## 6. ART IN PUBLIC PLACES

ADDENDUM #1  
CITY COMMISSION  
03/09/15

MEDITERRANEAN VILLAGE  
AT PONCE CIRCLE

# VALET OPERATIONS DIAGRAM - GROUND FLOOR

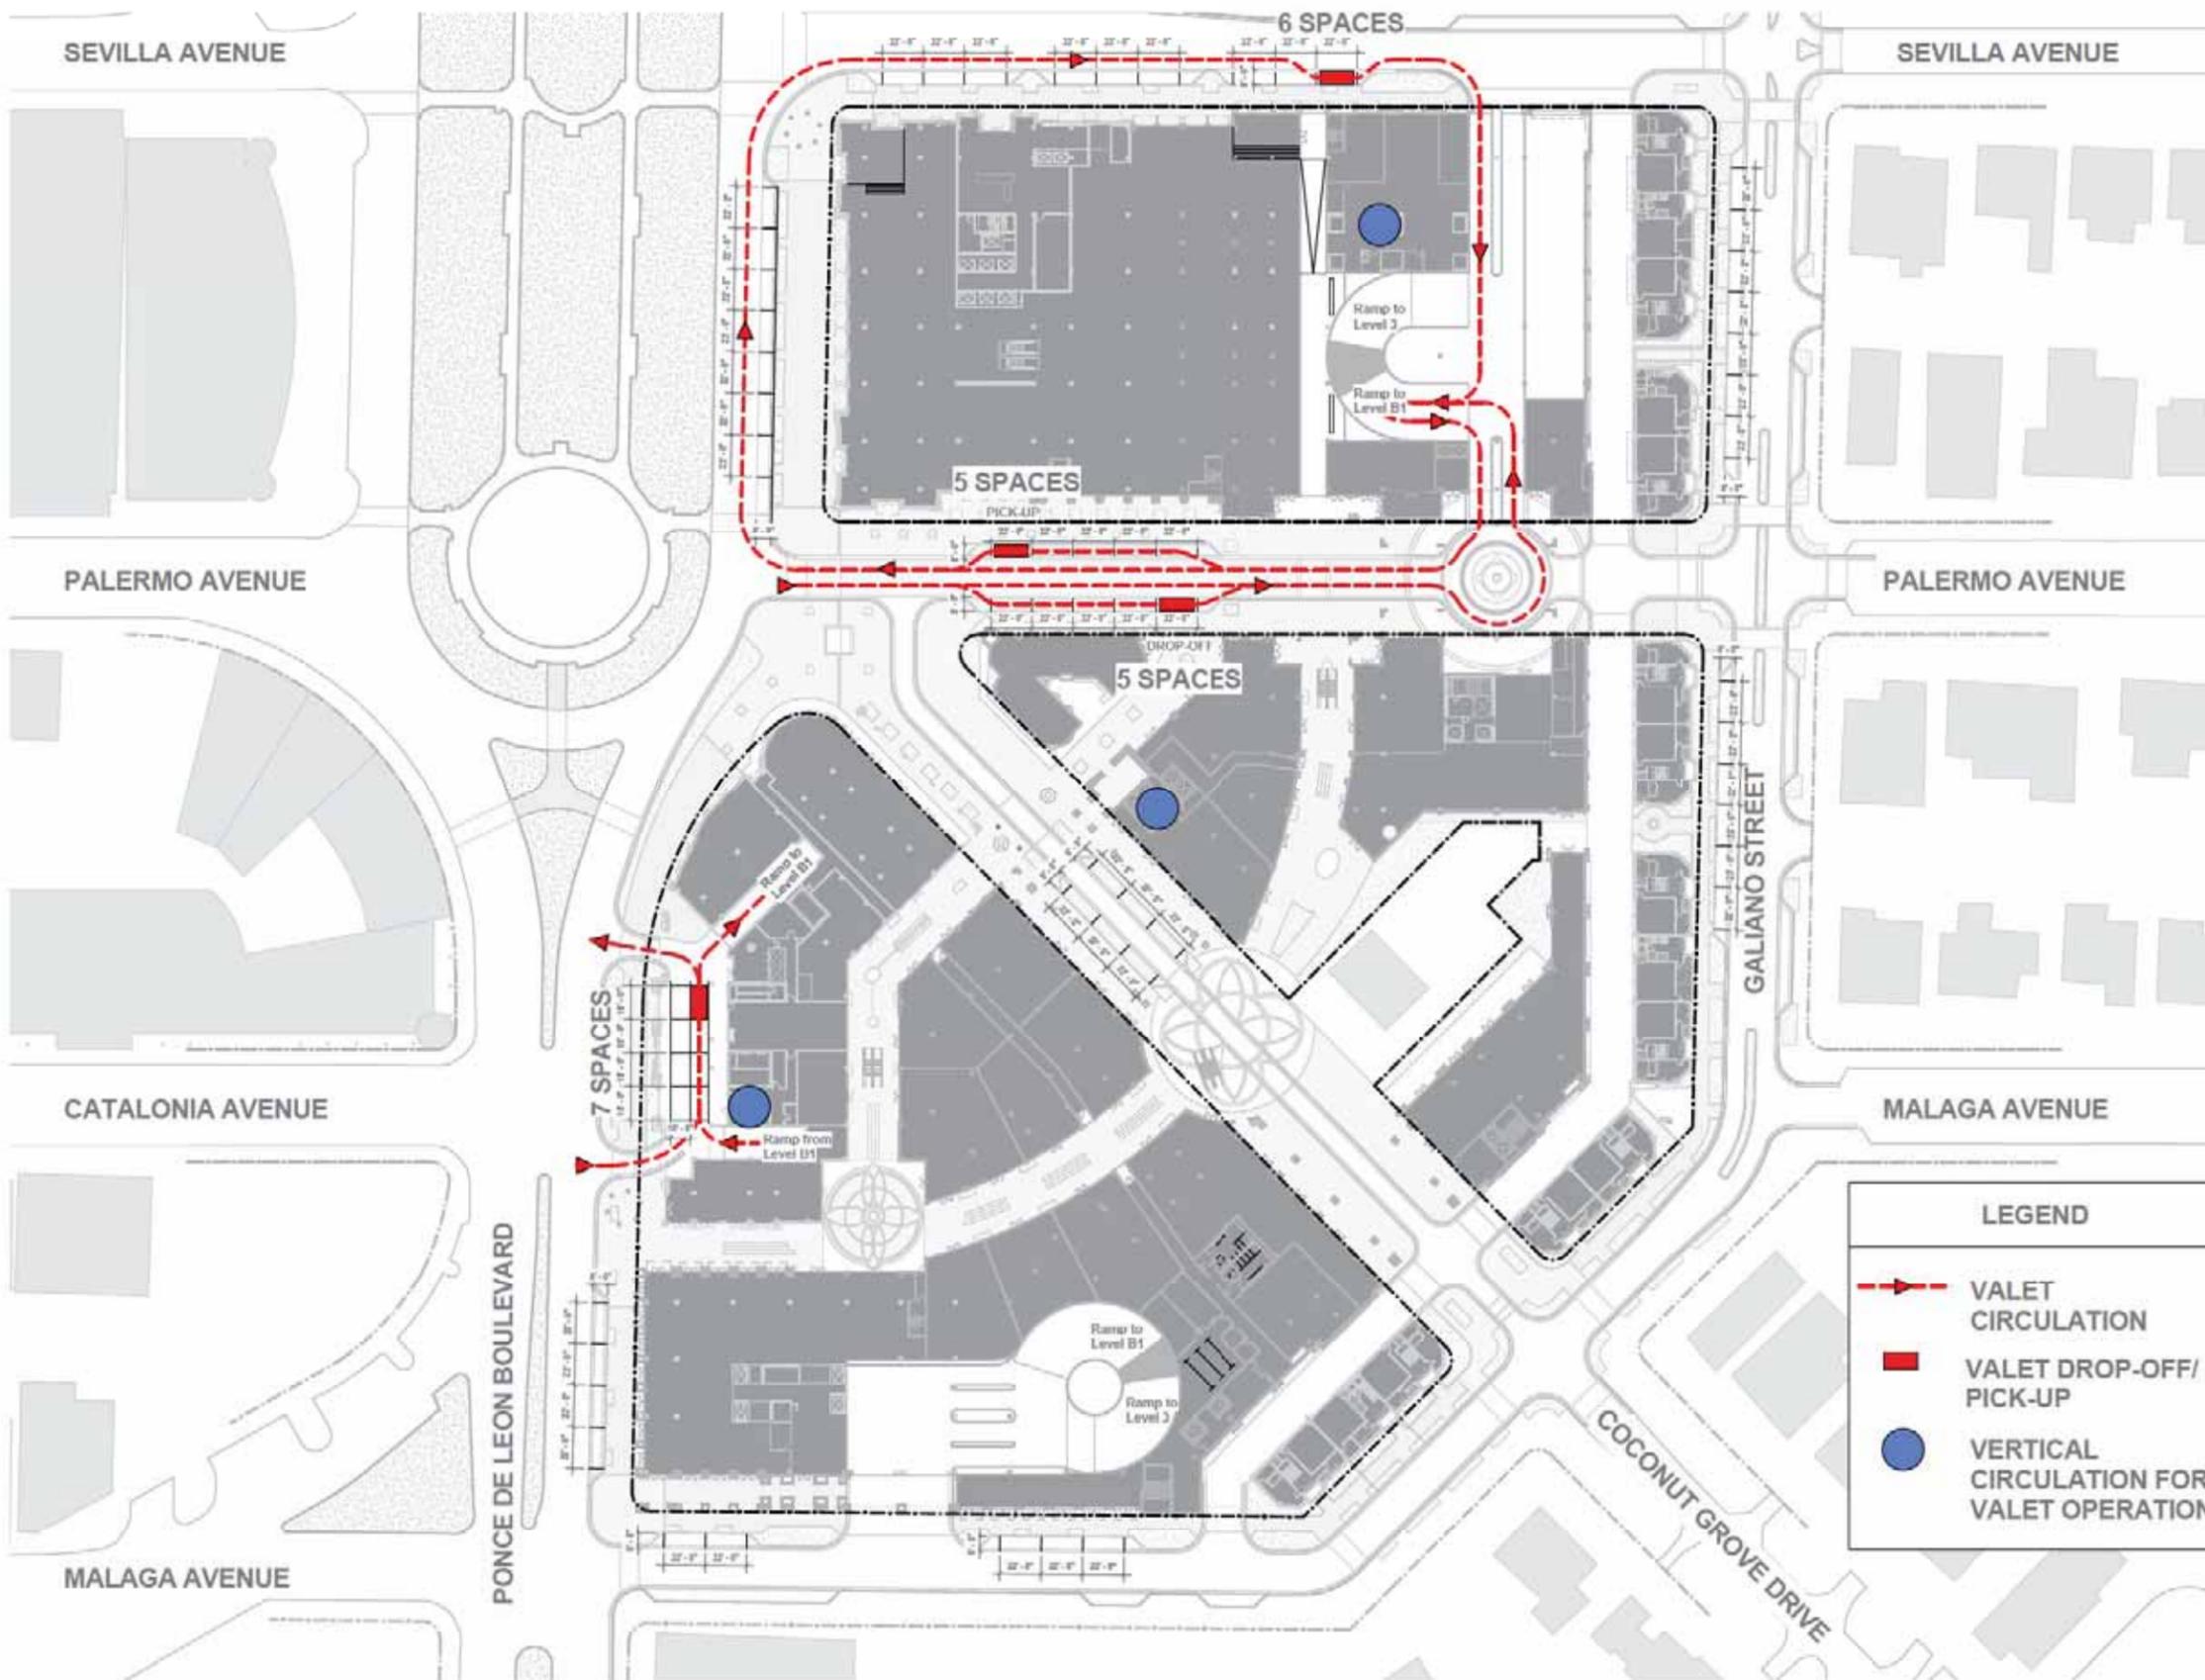
- A. The applicant should provide dimensions of the proposed valet drop-off / pick-up areas to verify the number of vehicles that can be accommodated. Exhibit A-0.11.6 shows the number of on-street spaces but no dimensions. This exhibit shows one parking space for the North valet station but the text and analysis references seven on-street parking spaces.

VALET SERVICE IS PLANNED FOR SEVERAL USES WITHIN THE OVERALL PROJECT FOR HOTEL GUESTS, RESIDENTIAL VISITORS, AND RETAIL PATRONS. ALL VALET PARKING WILL BE PROVIDED WITHIN THE LOWER BASEMENT LEVEL OF THE PARKING AREA. THE FOLLOWING SECTIONS SUMMARIZE THE ANTICIPATED LOCATION OF THE VALET STAND FOR EACH USE AND THE VALET ROUTE FOR EACH VALET STAND.

# FLOOR PLAN - BASEMENT LEVEL 2

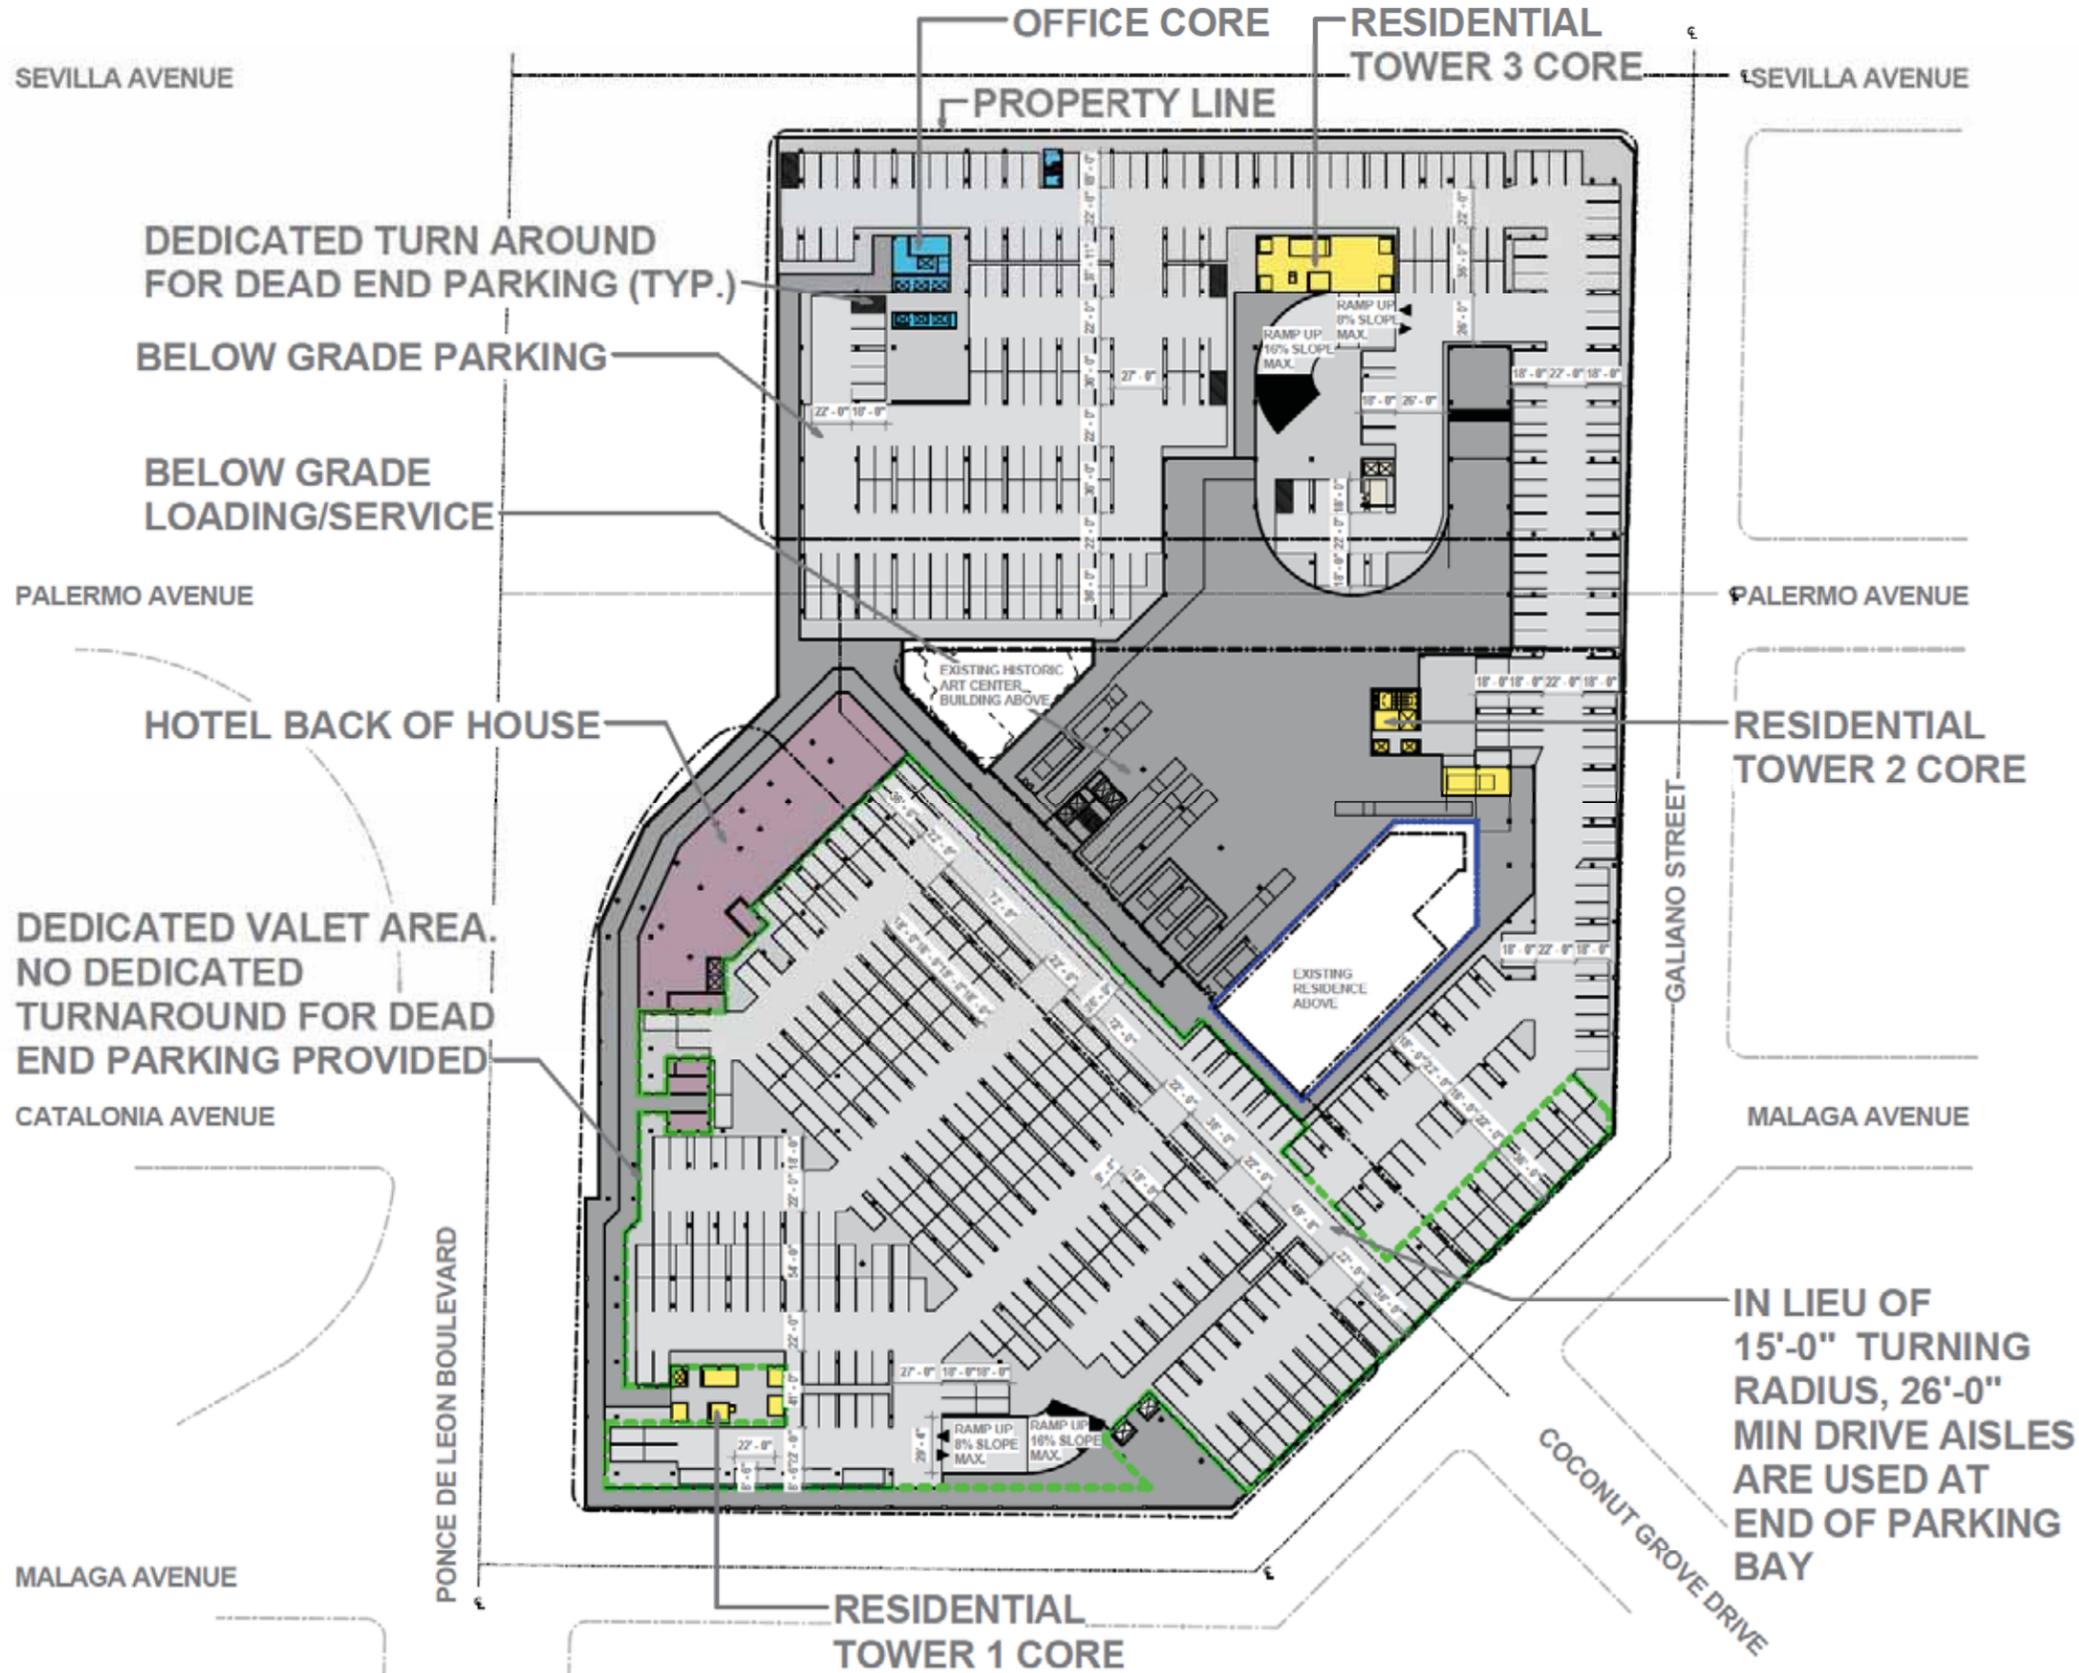
- A. The inside end of each drive aisle needs a 15-foot radius to allow for simultaneous turns. This is good design practice and is required by Miami-Dade County.
- B. Ideally, the garage shouldn't have any "dead-ends." If there are dead-ends, then turnaround areas are needed, which generally requires removal of parking spaces.
- C. There are many areas that need to show if vehicular maneuverability works using AutoTurn, especially in the loading areas, the circular ramps, etc.
- D. There are columns that are in conflict with the vehicle maneuvers.
- E. The city zoning code for parking requirements needs to be met.
- F. There are areas where parking spaces conflict with ramp circulation.
- G. Vehicular cross connections on levels 3 through 7 are not adequate for two-way traffic.
- H. Ramp grades that do not have parking on them ideally do not exceed 10% and should not exceed 12%.

IN LIEU OF 15'-0" TURNING RADIUS, 26'-0" MIN DRIVE AISLES ARE USED AT END OF PARKING BAY
